Access Compliance Report

Public Rights-of-Way

(Curb Ramps)

Intersection ID: N/A	Main Street: PARKWAY_PLAZA_BV	Cross Street: COURTNEY_COMMONS_LN	Location: SE
ADA ID: C6410F2AB1C8	Ramp Type: Directional1	Initial Pass/Fail: Fail	Overall Compliance: No
Codes/Mitigation Info/Possible Solution		Field Measurements/Component Compliance	
Severity Score: 33.75

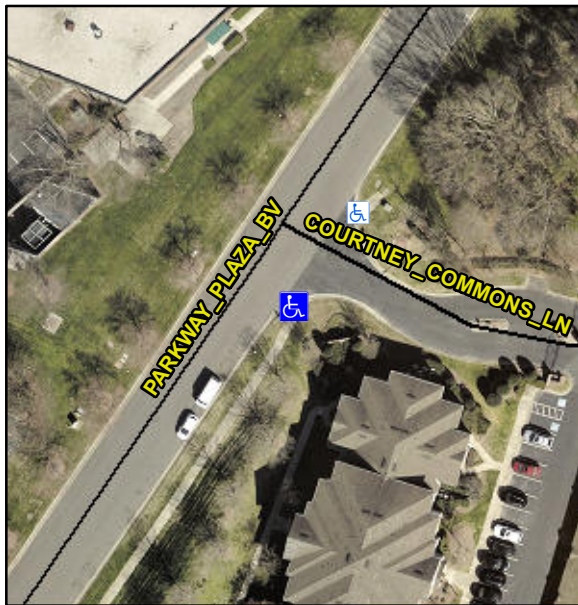
R304.5.1, R304.5.3

Compliance	Description	Data	Compliance	Description	Data
N/A	Ramp Length (in)	40.0	N/A	Grade Break?	N/A
No	Ramp Width (in)	43.0	N/A	Grade Break Slope (%)	0.0
Yes	Ramp Slope (%)	2.6	N/A	Grade Break XSlope (%)	0.0
No	Ramp XSlope (%)	8.0			
N/A	Flare Type LT	N/A	N/A	Flare Type RT	N/A
N/A	Flare Slope LT (%)	N/A	N/A	Flare Slope RT (%)	0.0
N/A	Flare Traversable LT?	N/A	N/A	Flare Traversable RT?	N/A
N/A	Landing Length (in)	0.0	N/A	DWS Provided?	N/A
N/A	Landing Width (in)	0.0	N/A	DWS Contrast?	N/A
N/A	Landing Slope (%)	0.0	N/A	DWS Length (in)	N/A
N/A	Landing X Slope (%)	0.0	N/A	DWS Full Width?	N/A
N/A	Landing Curb? (Y/N)	N/A	N/A	DWS Offset LT (in)	N/A
N/A	Shared Landing?	N/A	N/A	DWS Offset RT (in)	N/A
N/A	Gutter Ponding?	0.0	N/A	Gutter Slope (%)	N/A
N/A	Gutter Lip Ht (in)	0.0	N/A	Gutter X Slope (%)	N/A
N/A	Painted X Walk1?	No		Road Slope (%)	0.5
	X Walk 1 Direction	To N		Road X Slope (%)	8.5
	X Walk 1 Width (in)	N/A		Clear Space?	N/A

X Walk 1 Slope (%)	0.5	N/A	Clear Space to XWalk (in)	N/A
	X Walk 1 X Slope (%)	8.5	N/A	Storm Grate/Utility Hazard?	N/A
N/A	Ramp inside XWalk1?	N/A		Storm Grate/Utility Type	
N/A	Any Obstructions?	N/A			N/A
	Obstruction Type		Yes	Surface Condition? (G/P)	Good
			N/A	Curb Slope (%)	4.8

Remove & Replace Entire Ramp.
